TRANS/WP.29/2002/41
12 April 2002

PROPOSAL FOR DRAFT SUPPLEMENT 7 TO THE 09 SERIES OF AMENDMENTS
TO REGULATION No. 13

(Braking)

Transmitted by the Working Party on Brakes
and Running Gear(GRRF)

Figure 1B

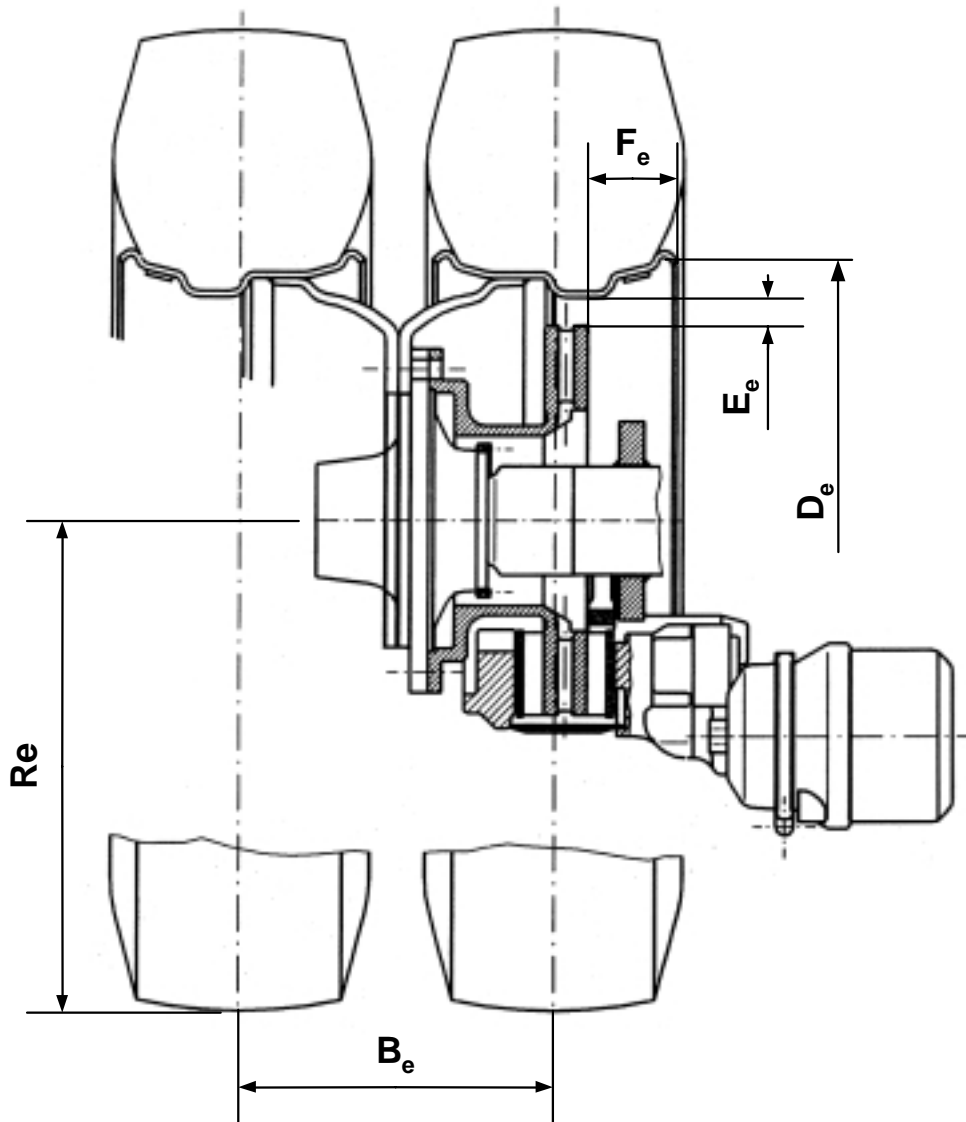
Figure 1, renumber as Figure 1A.

Insert a new Figure 1B for disc brakes, to read:

Be (mm)	De (mm)	Ee (mm)	Fe (mm)	Re (mm)

Figure 2B

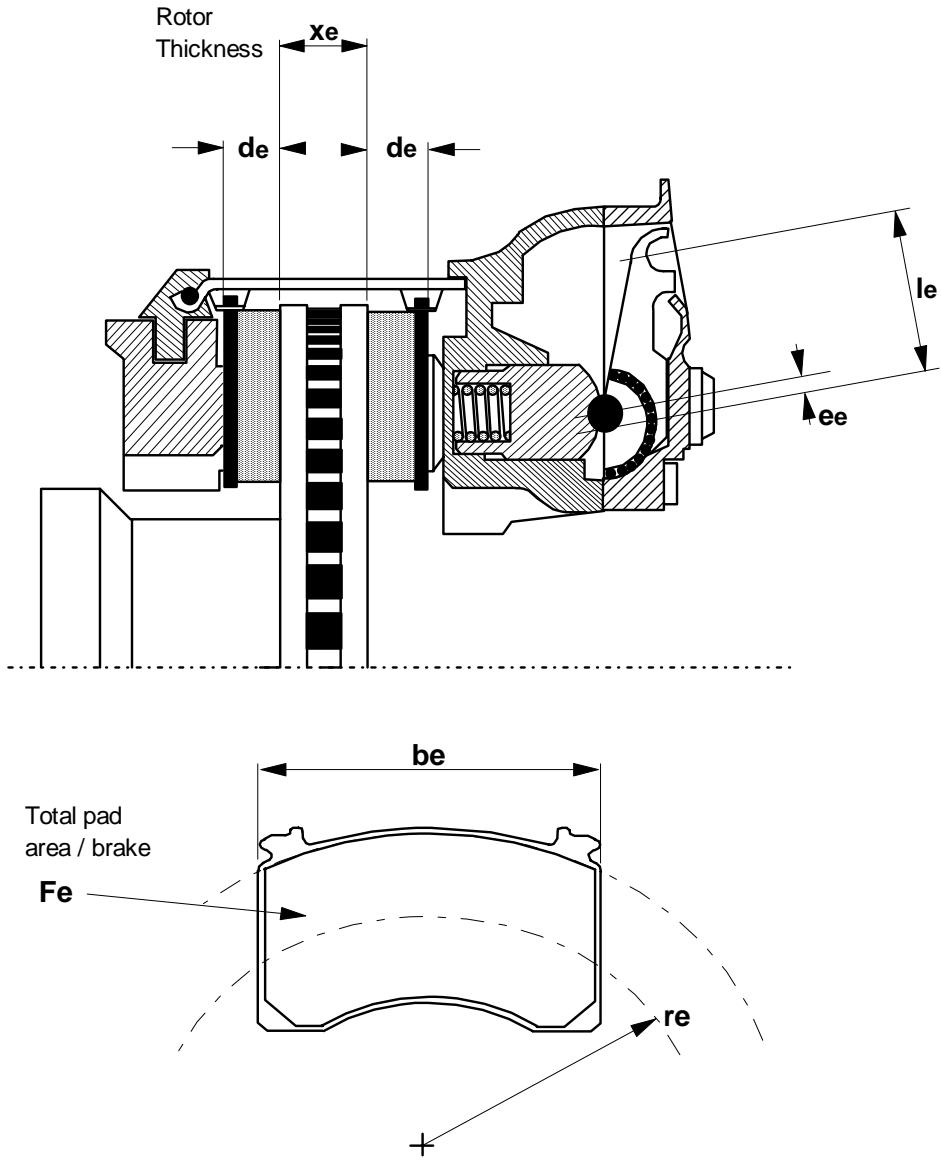
Figure 2, renumber as Figure 2A.

Insert a new Figure 2B for disc brakes, to read:

l_e (mm)	e_e (mm)	d_e (mm)	x_e (mm)	r_e (mm)	b_e (mm)	F_e (cm^2)

DIAGRAM 1

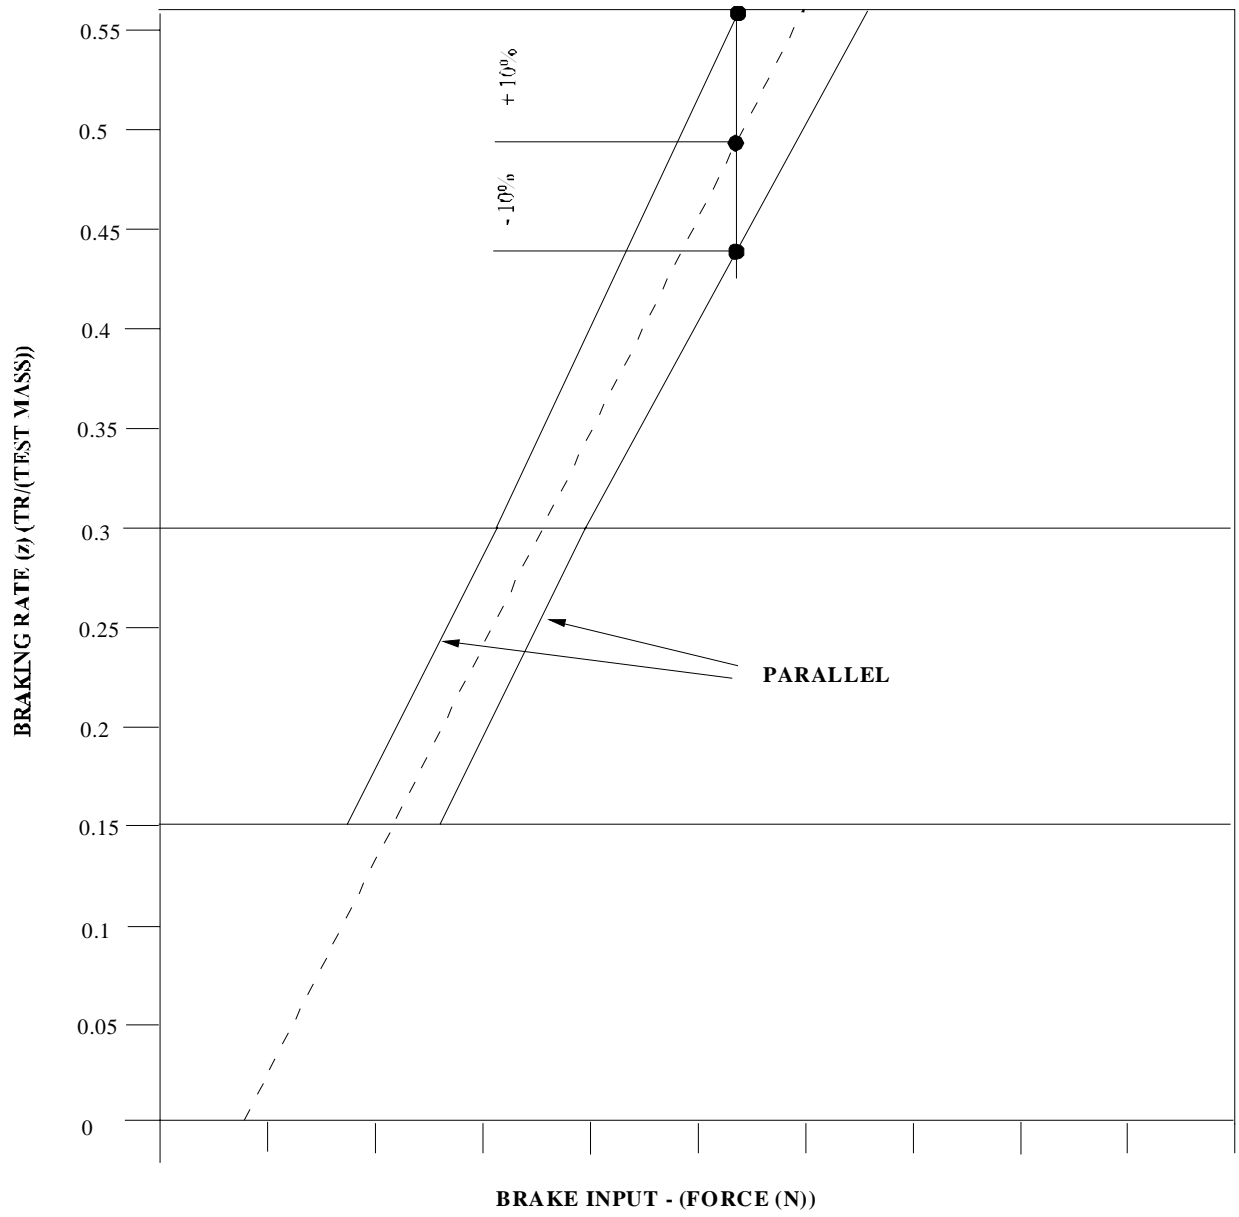
- 4.3.2.2. The declared brake factor B_F
 - 4.3.2.3. The declared threshold torque C_0
- 4.4. Test procedure
 - 4.4.1. Preparation
 - 4.4.1.1. A graph defining the acceptable performance variation shall be constructed, following the model shown in Diagram 1, using the manufacturers declared brake factor.

- 4.4.3.5. For each of the brake applications in paragraph 4.4.3.4. the braking rate is calculated, corrected to take account of rolling resistance, and plotted on the graph specified in paragraph 4.4.1.1. of this annex.

VERIFICATION GRAPH FOR PARAGRAPH 3.2.1.5. - SEMI TRAILERS

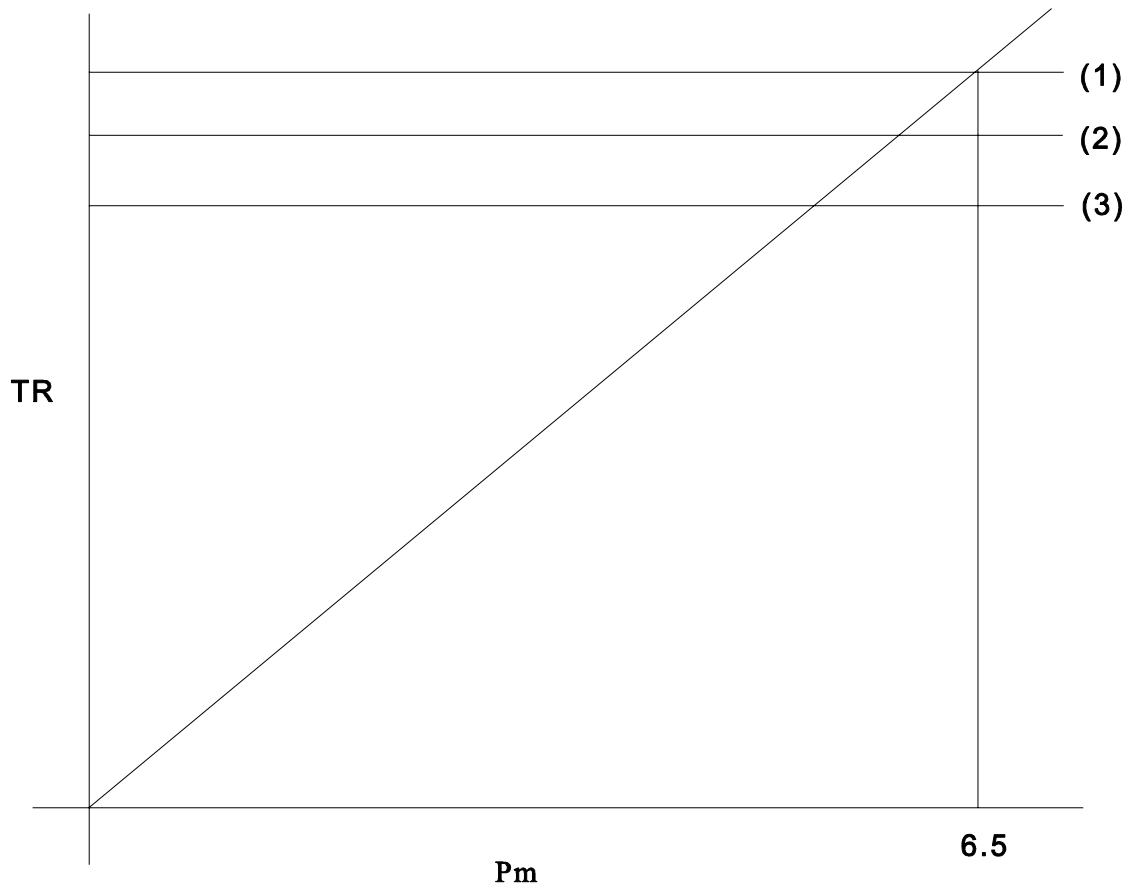
(1) = TR_{max} , when $p_m = 6.5$ bar and supply line = 7.0 bar.

VERIFICATION GRAPH FOR PARAGRAPH 3.2.1.6 - CENTRE AXLE TRAILERS

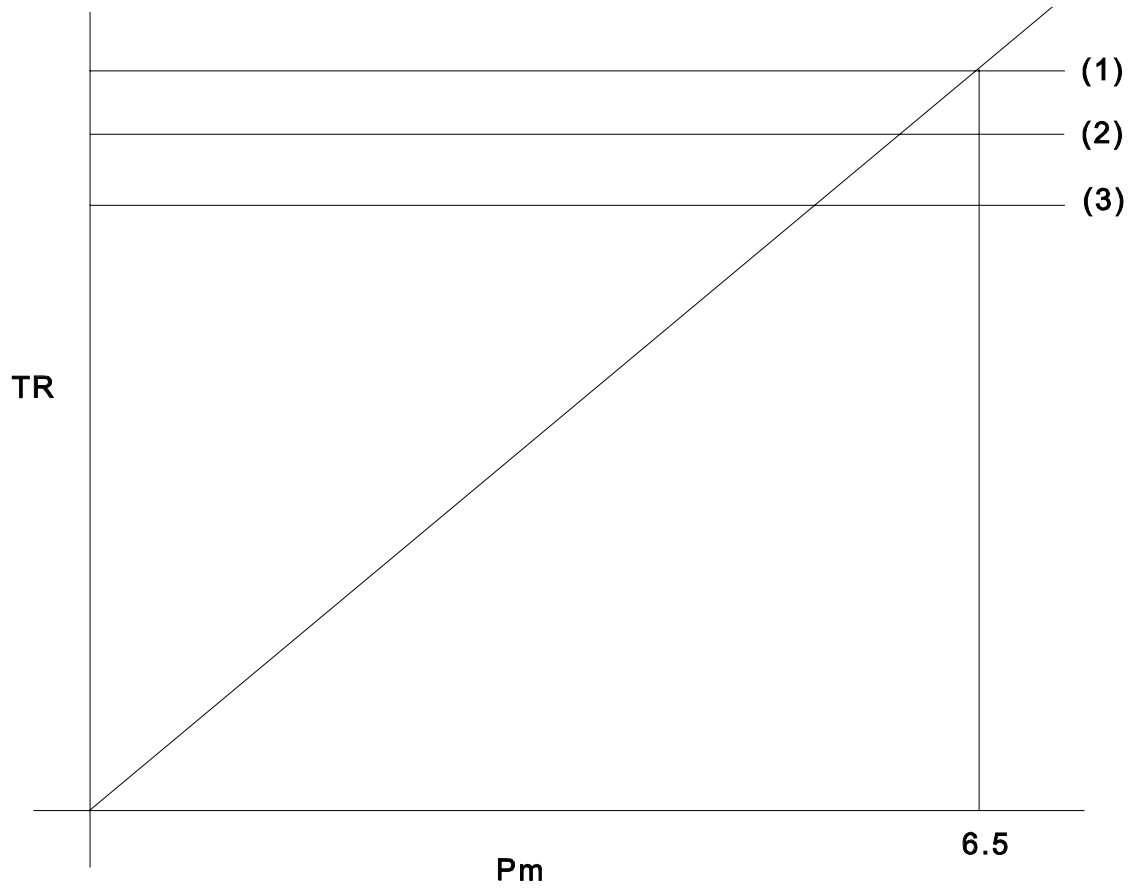
(1) = TR_{max} , when $p_m = 6.5$ bar and supply line = 7.0 bar.

VERIFICATION GRAPH FOR PARAGRAPH 3.2.1.7. - FULL TRAILERS

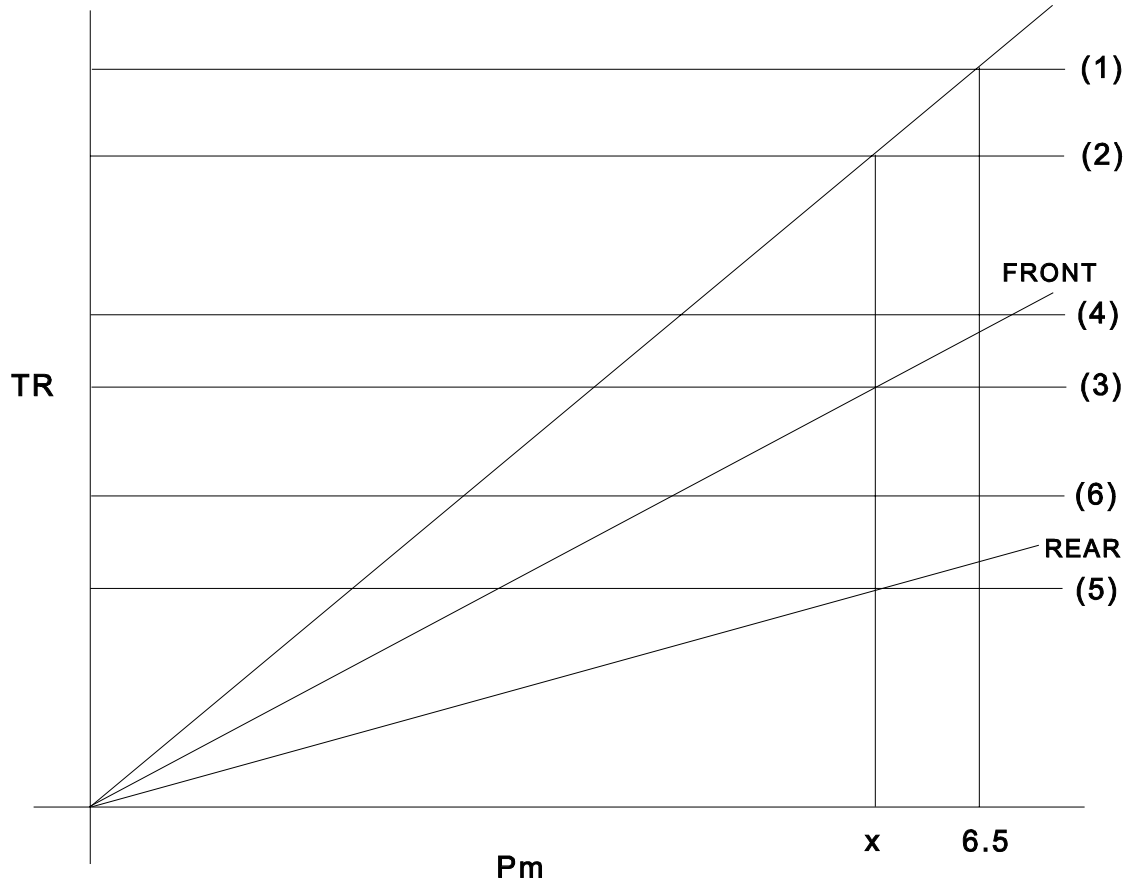
(1) = TR_{max} , when $p_m = 6.5$ bar and supply line = 7.0 bar.
